NIAGARA FALLS AIR RESERVE STATION

MILITARY ENTRANCE PROCESSING STATION

PN 59873

INVITATION FOR BID DECEMBER 2004

Sheet reference number:
S–103

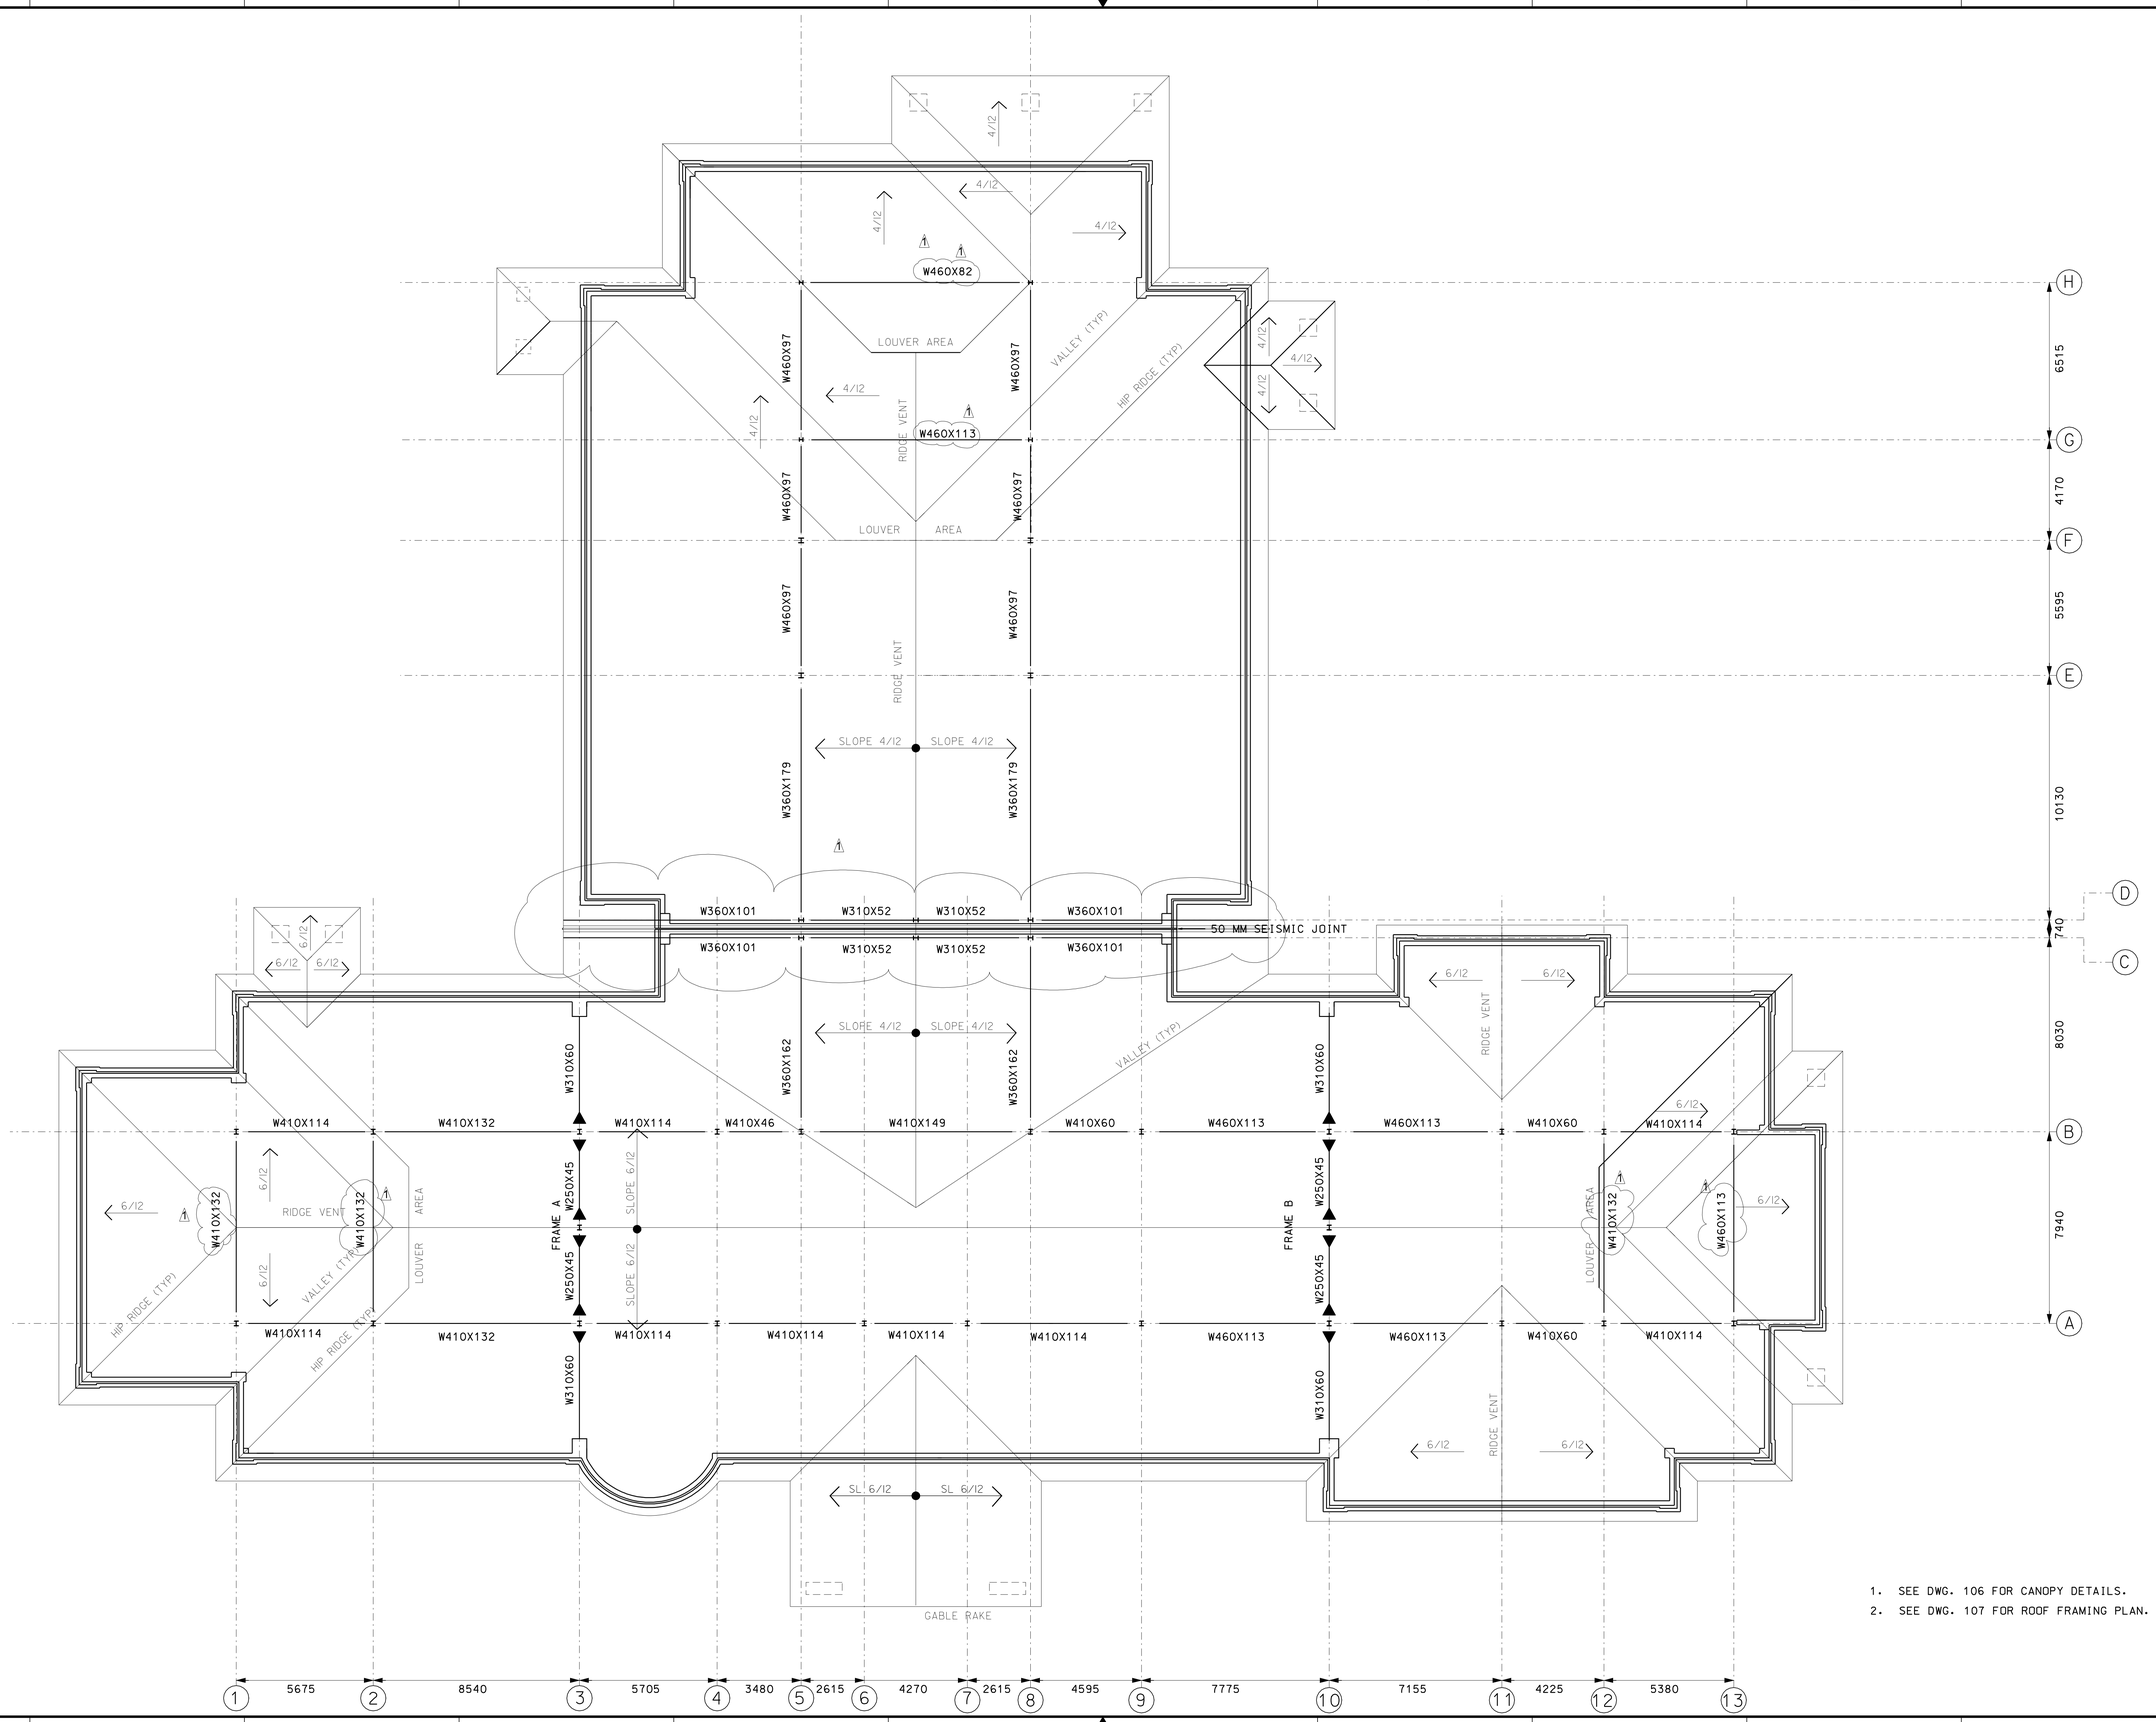
Symbol	Description	Date	Appr.
1	AMENDMENT 1 - INCORPORATED ADDITIONAL BEAMS	12/20/04	
	90% SUBMISSION	10/14/04	
	60% SUBMISSION	09/09/04	
	35% SUBMISSION	08/19/04

Sheet reference number:
S–107

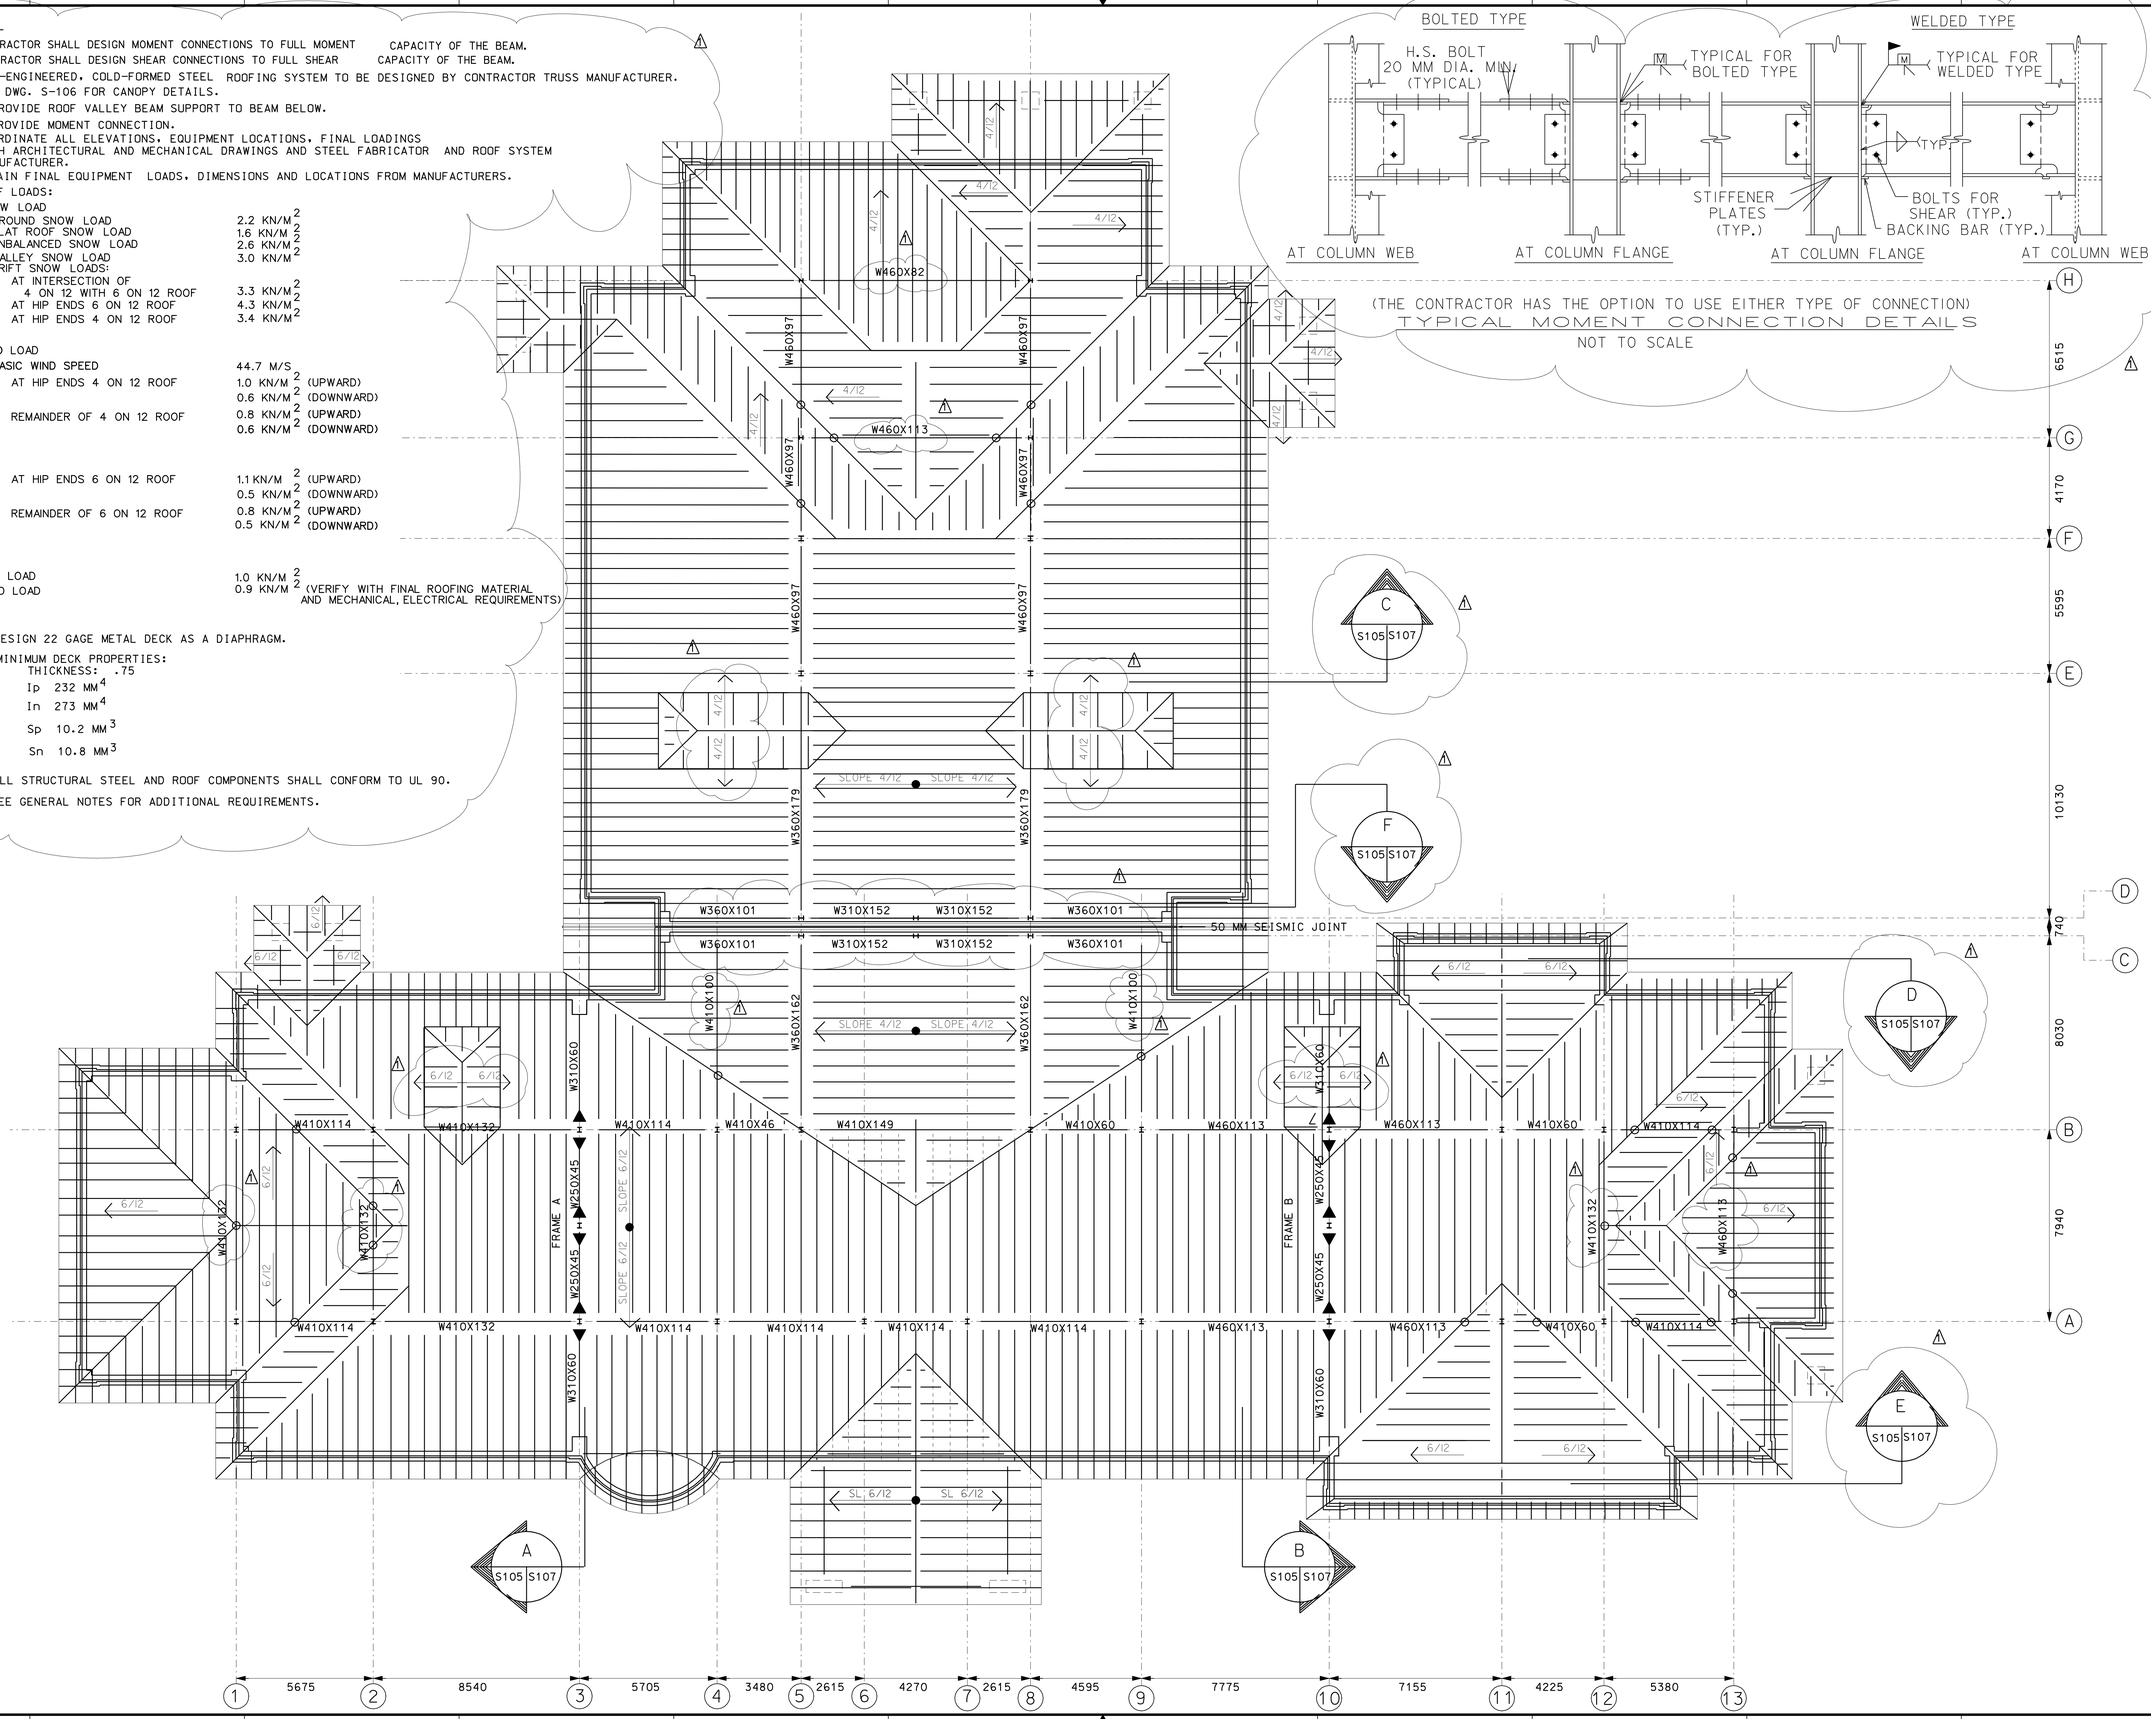
Symbol	Description	Date	Appr.
1	AMENDMENT 1 – INCLUDED DORMER SLOPES, MOVED CONNECTION DETAIL FROM S-105, ADDED ADDITIONAL NOTES, BEAM DESIGNATIONS AND SECTION LOCATORS	12/02/04	
	90% SUBMISSION	10/14/04	
	65% SUBMISSION	08/30/04	
	35% SUBMISSION	03/19/04

Sheet reference number:
S–108

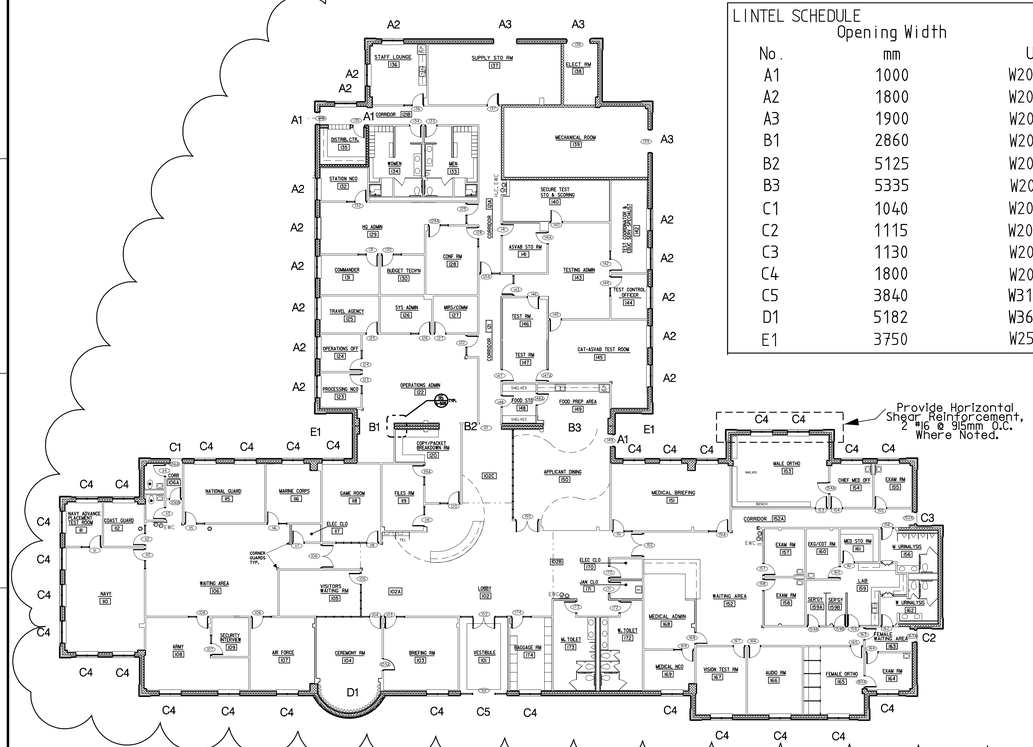
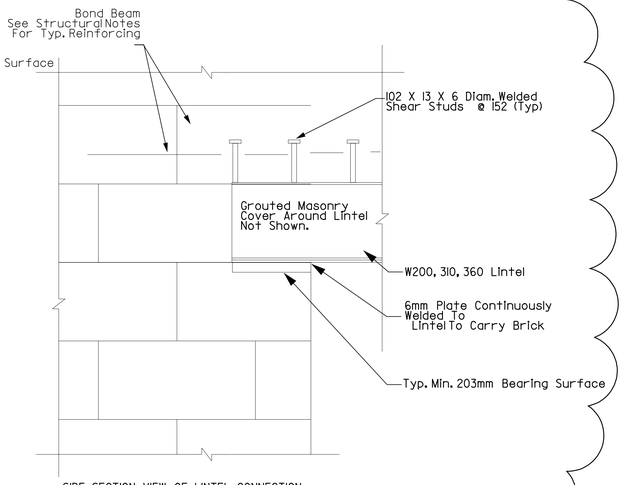
Symbol	Description	Date	Appr.
1	ADMIN SUBMISSION LINTEL SCHEDULE AND LINTEL DETAIL	12/10/04	
	90% SUBMISSION	10/14/04	
	60% SUBMISSION	08/19/04	
	35% SUBMISSION	03/19/04

No.	Opening Width mm	USE
A1	1000	W200X46
A2	1800	W200X46
A3	1900	W200X46
B1	2860	W200X46
B2	5125	W200X46
B3	5335	W200X46
C1	1040	W200X46
C2	1115	W200X46
C3	1130	W200X46
C4	1800	W200X46
C5	3840	W310X67
D1	5182	W360X79
E1	3750	W250X80
